**NH-IM-575-1(33)**

***I-575 Interchange at SR-20***

# **Value Engineering Study Report**

**Preliminary Design**

Alternative MIC  
Sketch #1

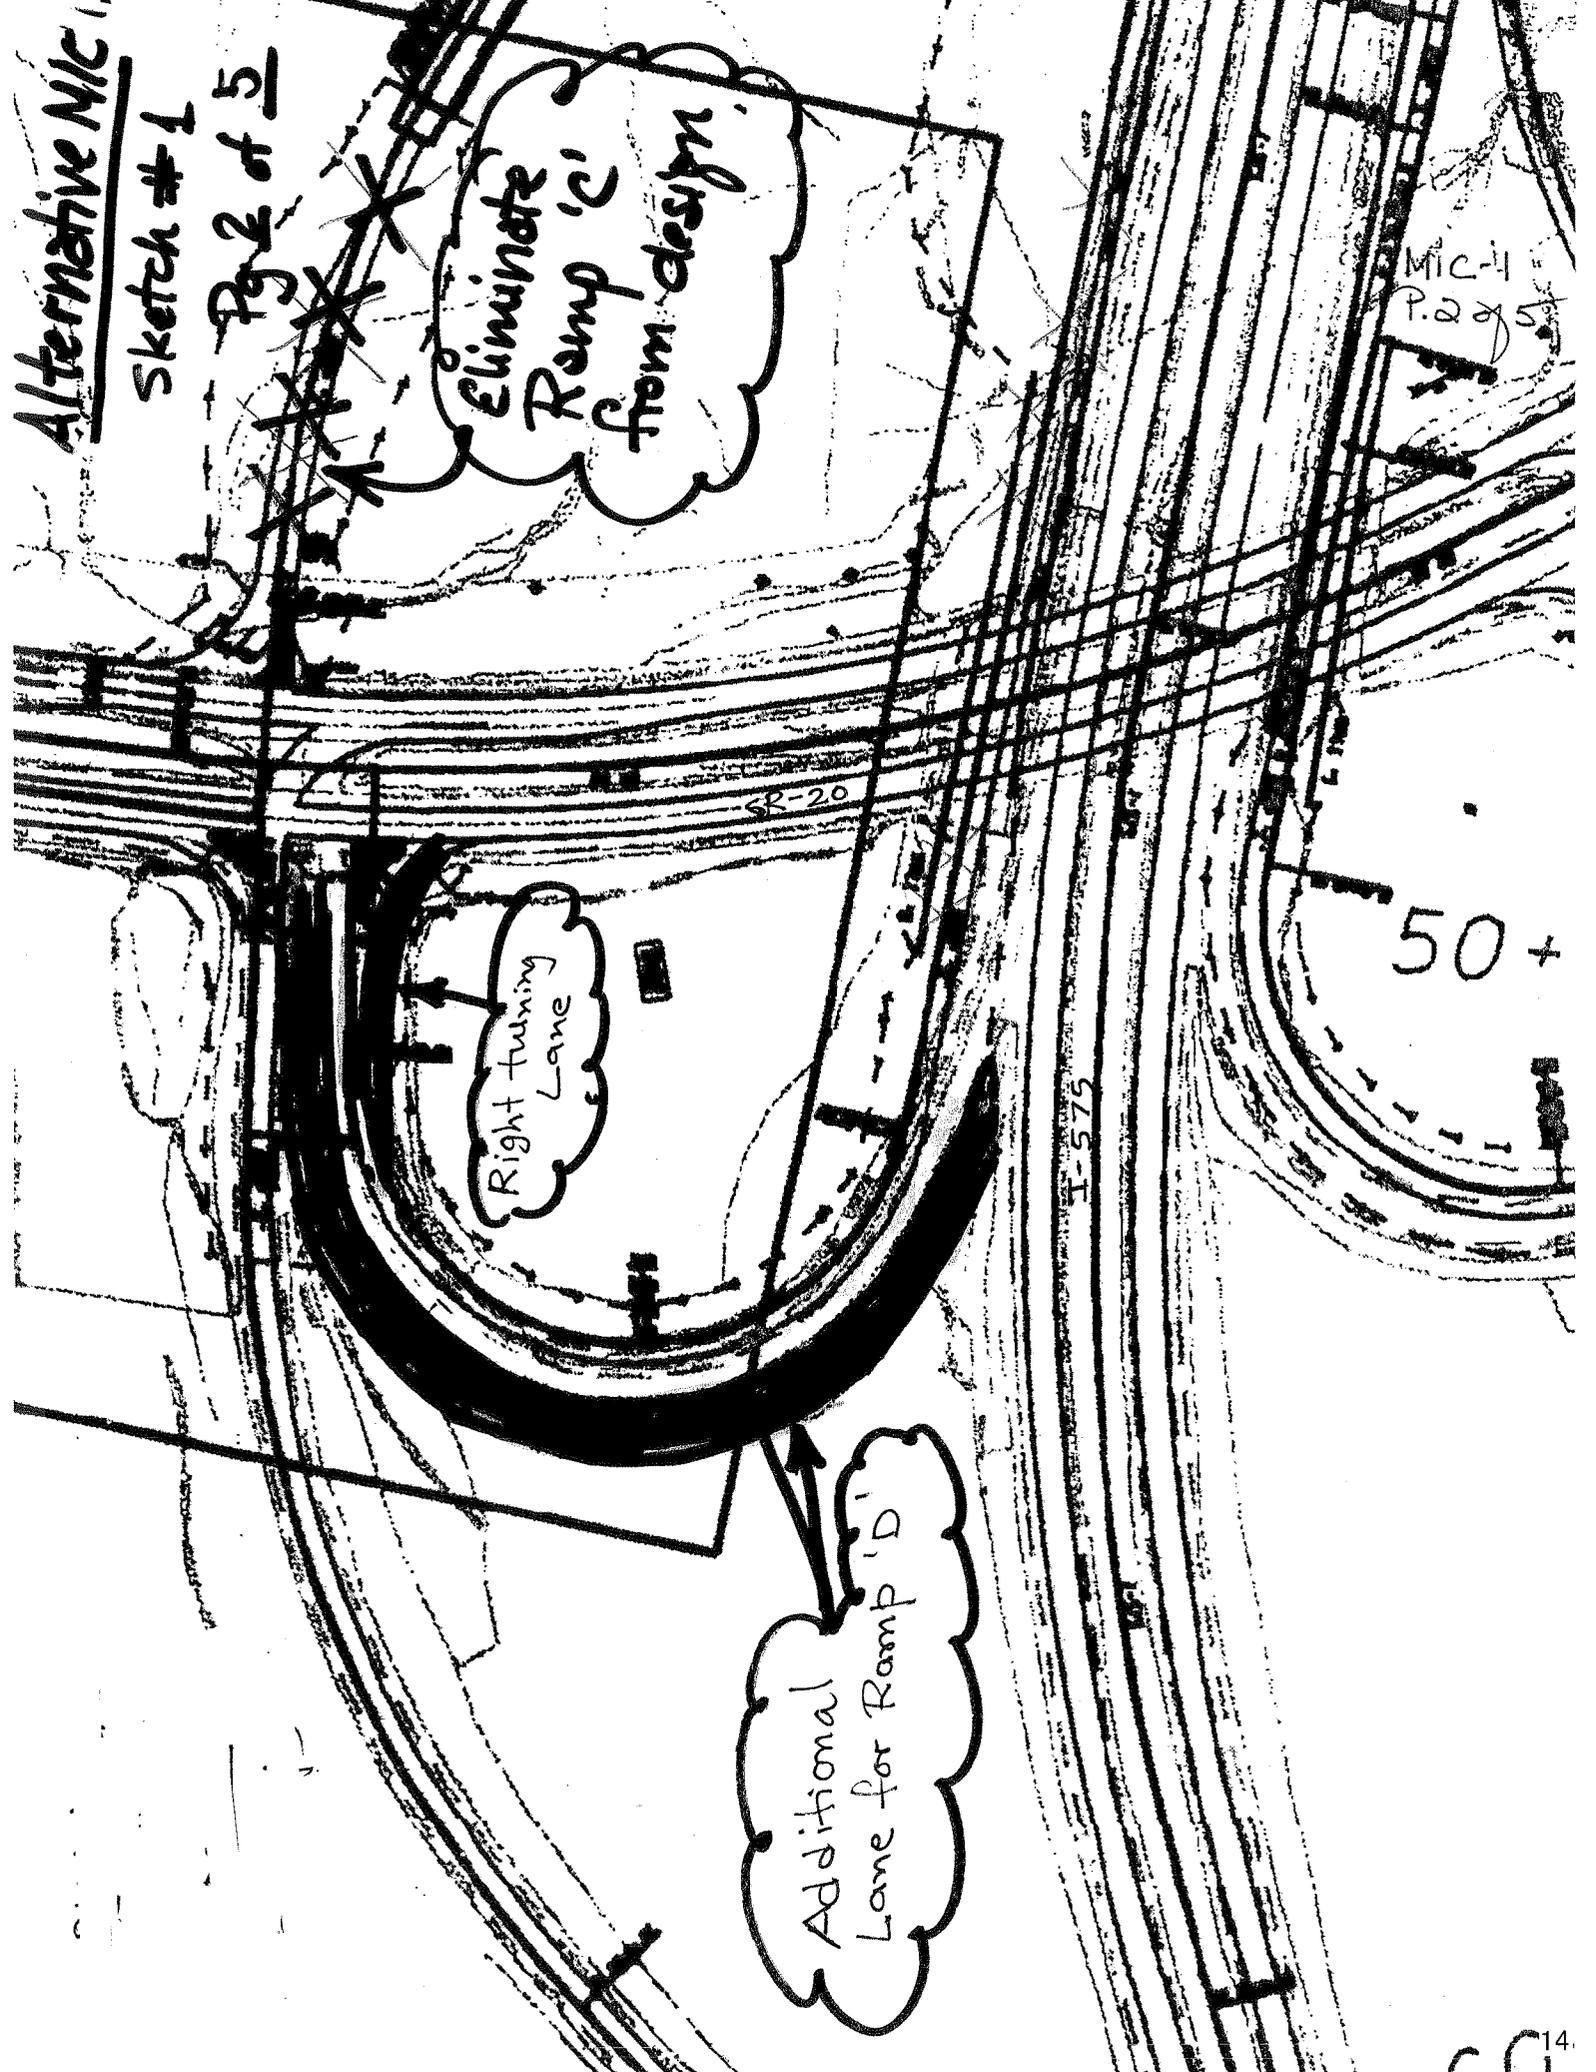
The addition of proposed Ramp "C" to the SR-20/I-575 interchange has shifted the Ramp "D" deceleration lane about 30 ft. to the east with a 3,400-ft. deceleration lane (Station 8+75 to 42+75). Ramp "D" and Ramp "C" separate at Station 33+00. The existing condition for the Ramp "D" deceleration lane appears to adhere to GDOT standards.

Retain existing Ramp "D" and make it double laned. Increase the phase time and add two left turn signals at SR-20. Currently during peak hours, vehicles queue up to several hundred feet on I-575. This queuing can be alleviated by the addition of the second lane to Loop Ramp "D," providing an additional 900 ft. of storage and two turning lanes for high-volume movement (NB 575/EB 20). The right turn lane (NB 575/WB 20) at the terminus of Ramp "D" will provide a free right turning lane with 200 ft. of storage. The deceleration lane at the diverge point with I-575 can be lengthened if it is believed that exiting vehicles will not be able to negotiate the tight turning radius on Ramp "D."

This alternative may remedy the congestion at the Ramp "D"/SR-20 terminus while addressing the ramp queuing issue onto NB 575 without the high cost and environmental impact associated with Ramp "C." A traffic simulation model can quickly assess the level of service at Intersection #2 (Ramp "D" and SR-20).

SHEET NO.: 2 of 5

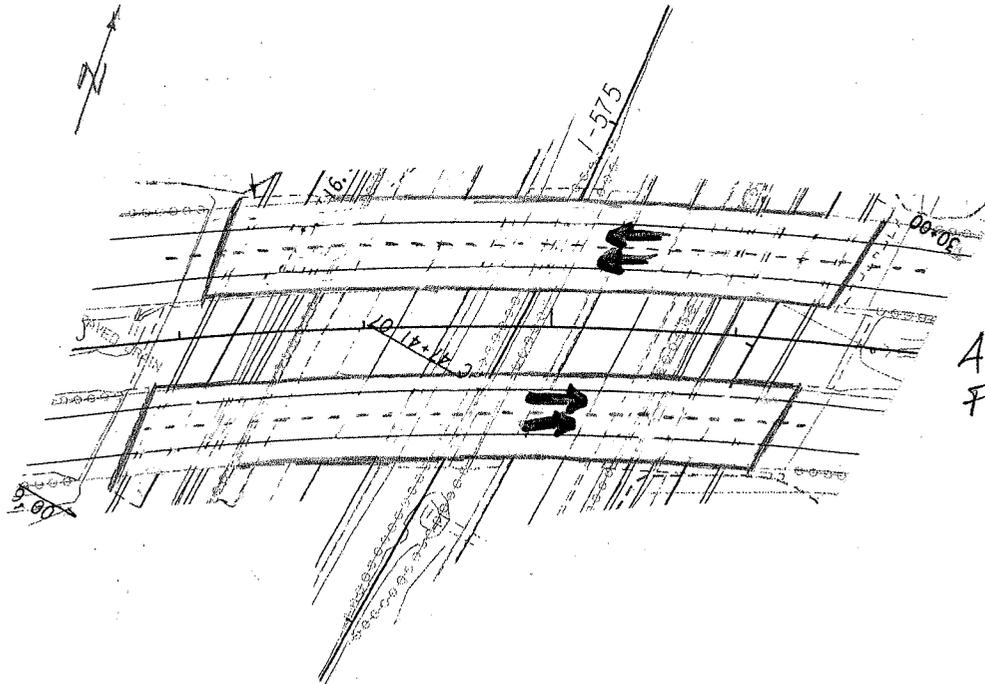
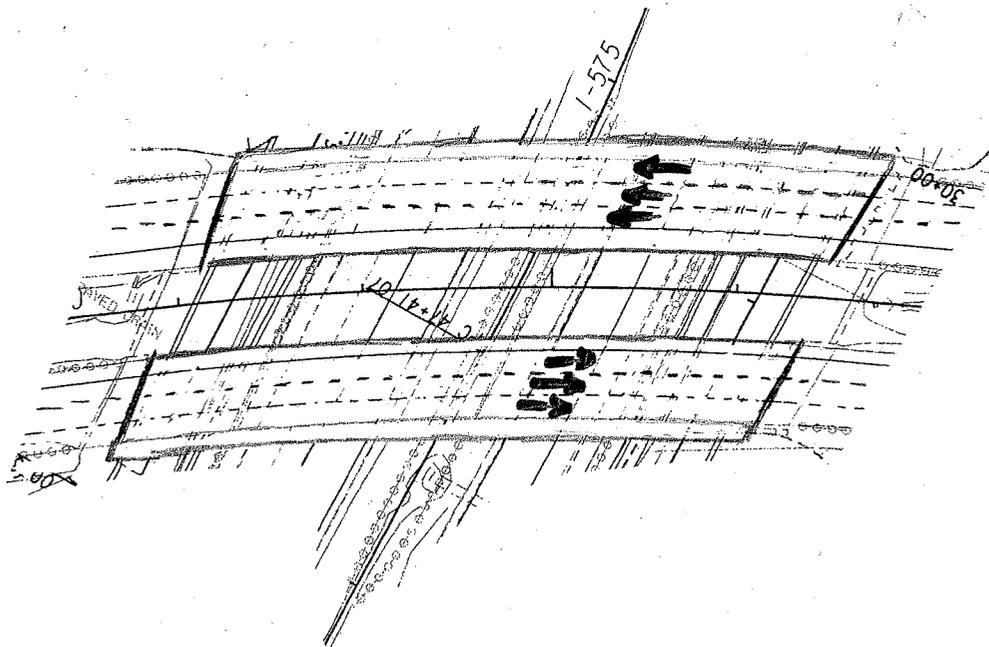
The original design uses the existing two lanes for SR-20.

Add one lane in each direction on SR-20 between the location of the proposed parkway east of the SR-20/I-575 interchange and Brown Industrial Parkway.

Although the traffic analysis does not warrant the addition of lanes proposed in this alternative, this proposal may improve the viability of other interchange configurations proposed in this VE study that do not provide the level of service in the current design.

ALTERNATIVE NO.: MIC-3

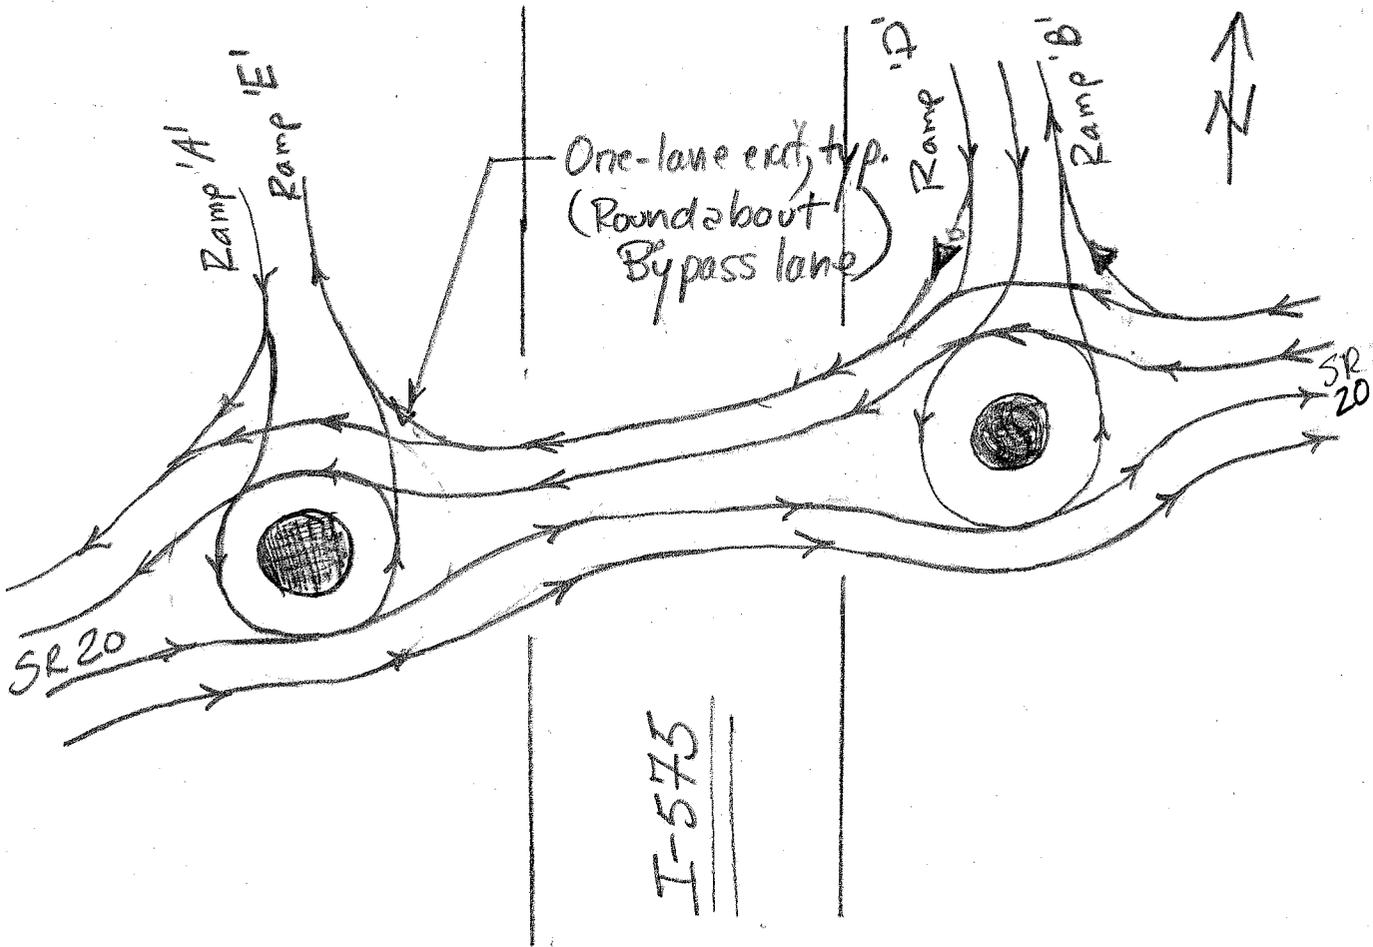
This alternative may provide the necessary additional traffic capacity and improved safety at a fraction of the cost. It also eliminates the environmental impact and significantly reduces the project duration. This solution would need an operational analysis to confirm viability. On the surface, it would benefit the turning movements at the expense of throughput on SR-20.

ALTERNATIVE NO.: MIC-5

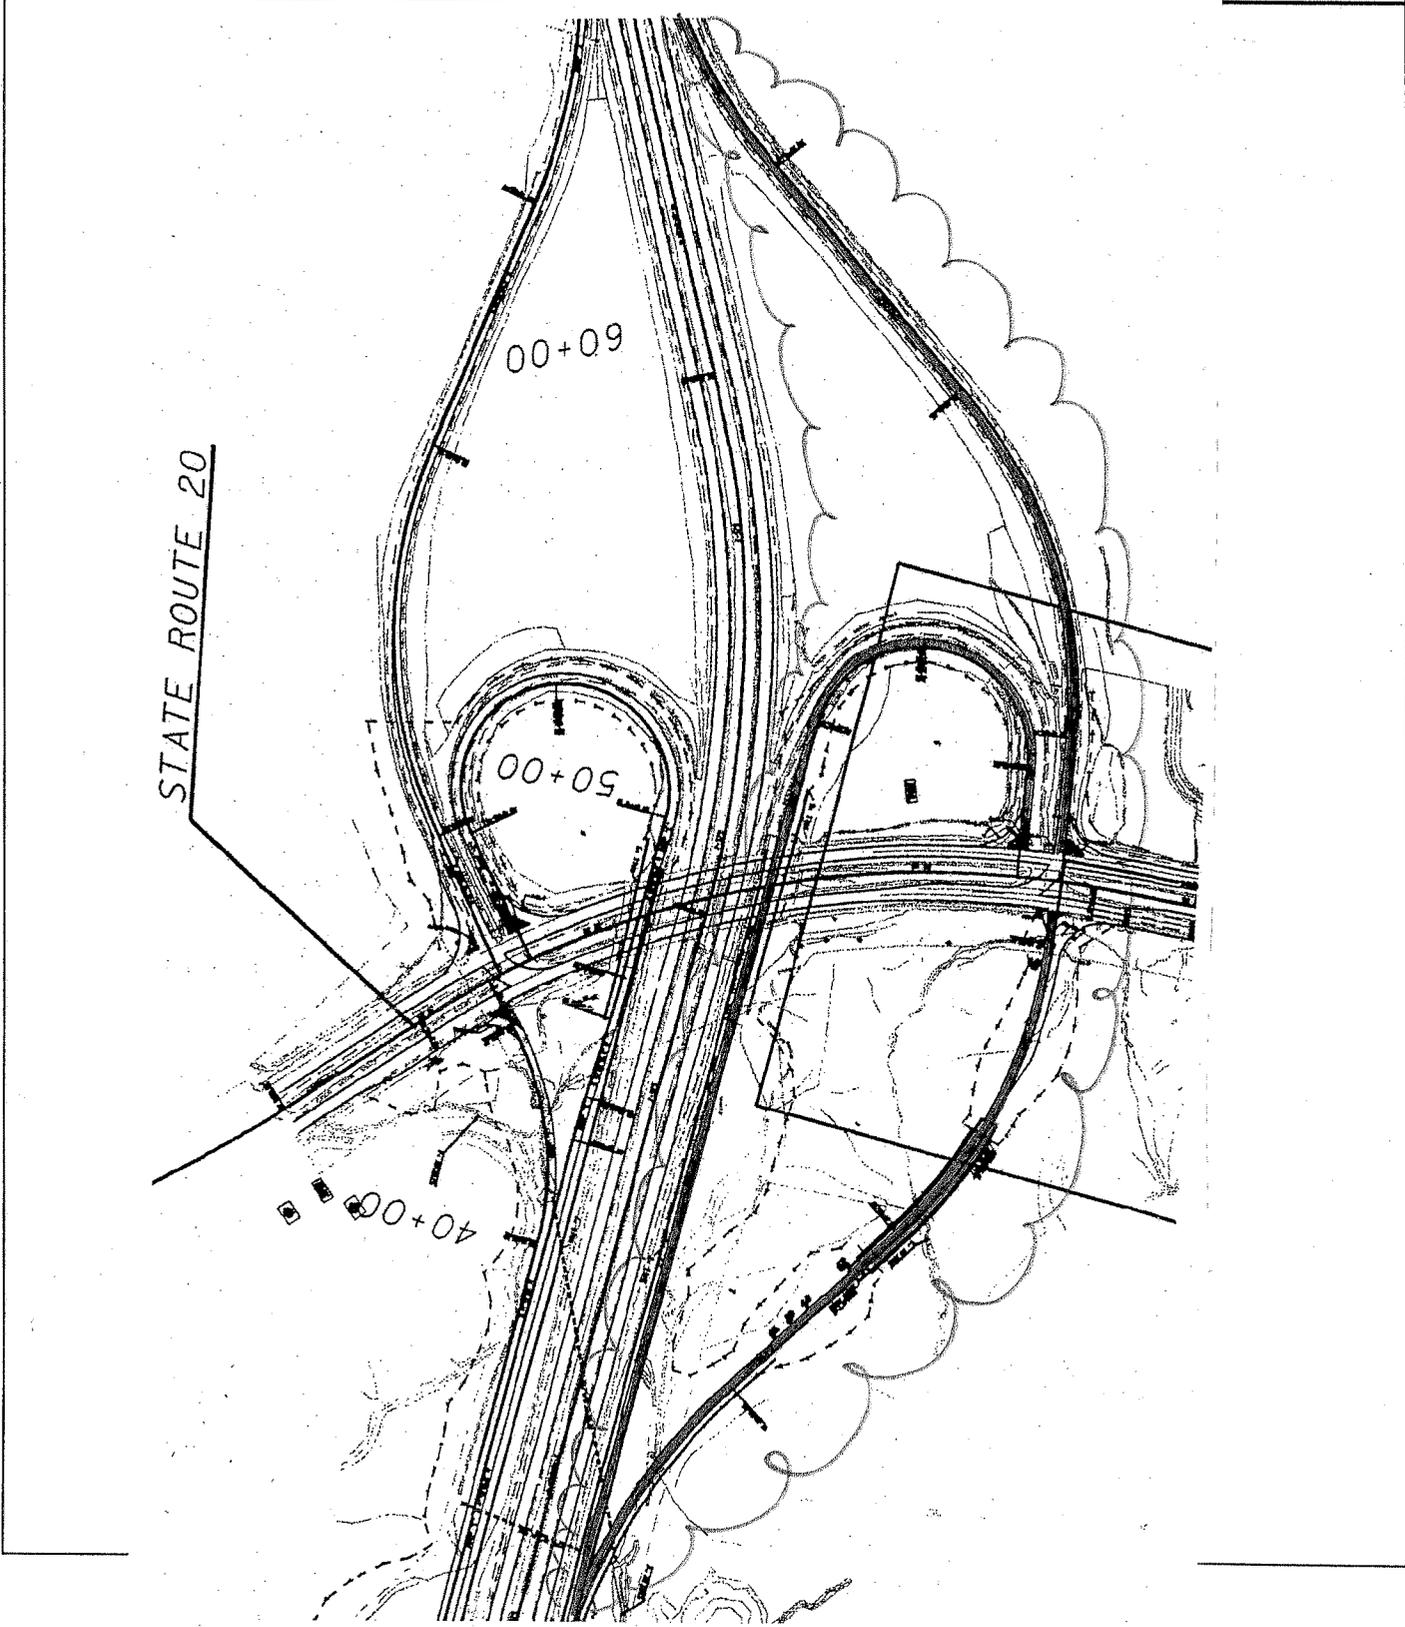
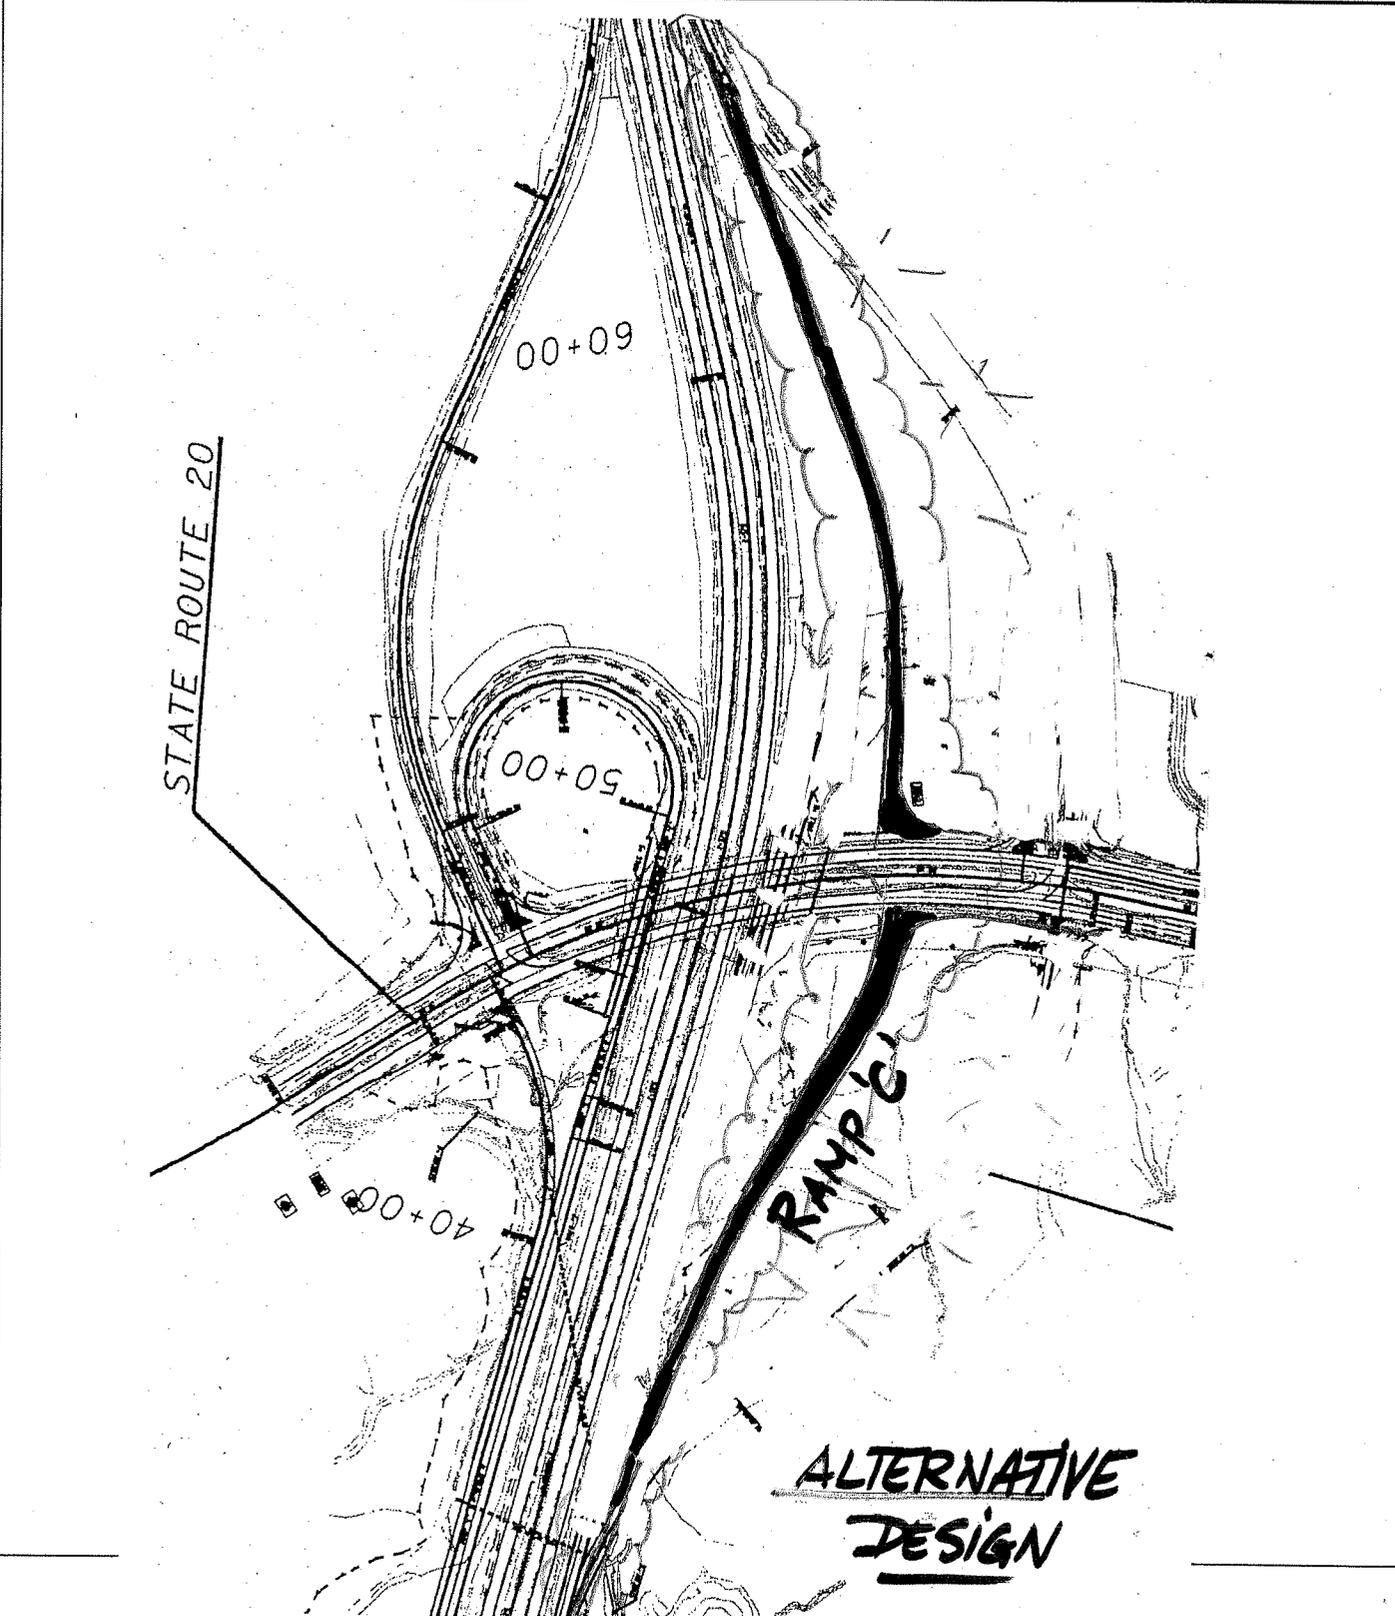
Replace existing northbound-to-westbound loop ramp (Ramp "D") with a higher capacity northbound-to-eastbound slip ramp (Ramp "C"). This two-lane ramp would accommodate the northbound-to-westbound movement with signalized dual left turn lanes. The ramp terminal intersection would be shifted 200 ft. west of the existing intersection.

GDOT should verify operational acceptability with additional traffic modeling. This alternative could be modified to a roundabout intersection as described in Alternative No. MIC-3.
